State of California  
AIR RESOURCES BOARD

Executive Order G-70-2-G

Relating to the Modification of the Certification of the  
OPW Model A-7 2 Point Vapor Recovery System for Underground  
Storage Tanks at Gasoline Service Stations.

Executive Order G-70-2-G  
EXHIBIT 3  
OPW MODEL A-7  
PHASE 1 VAPOR RECOVERY SYSTEM

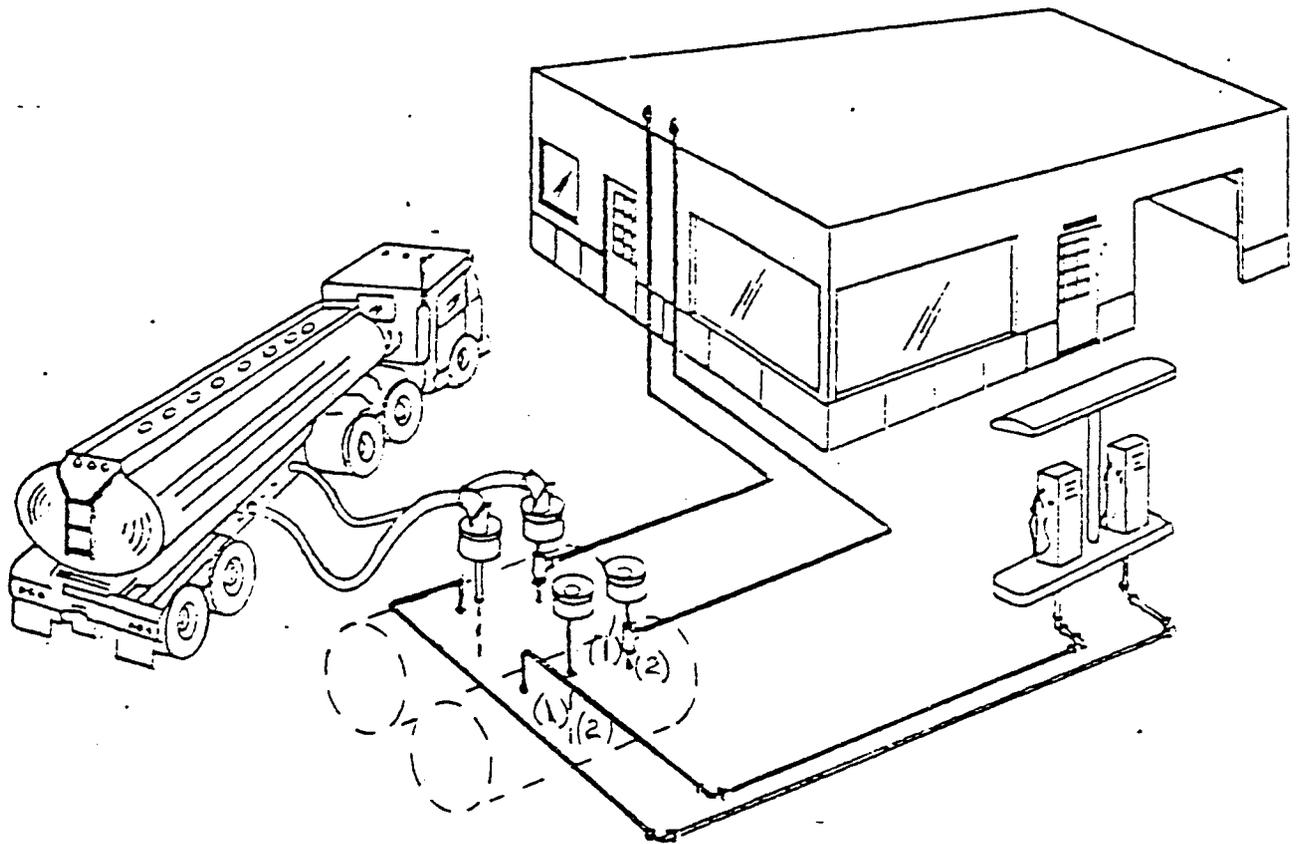
WHEREAS, Dover Corporation/OPW Division ("OPW") has applied for certification to add optional components, for the purpose of overfill protection, to the certification of the existing OPW Model A-5 Phase I vapor recovery system. The modified system, referred to as an OPW Model A-7 Phase I vapor recovery system, incorporates an OPW Model 233 VM Extractor S/A, and an OPW Model 53 VM Float Vent Valve.

Note: All other acceptable components are listed on Exhibit 1 and Exhibit 2.  
The OPW Model A-7 Phase I vapor recovery system is not approved for use at service stations equipped with Red Jacket or Healy Phase II vapor recovery systems.

- (1) OPW 233VM Extractor S/A.
- (2) OPW 53VM Float Vent Valve.
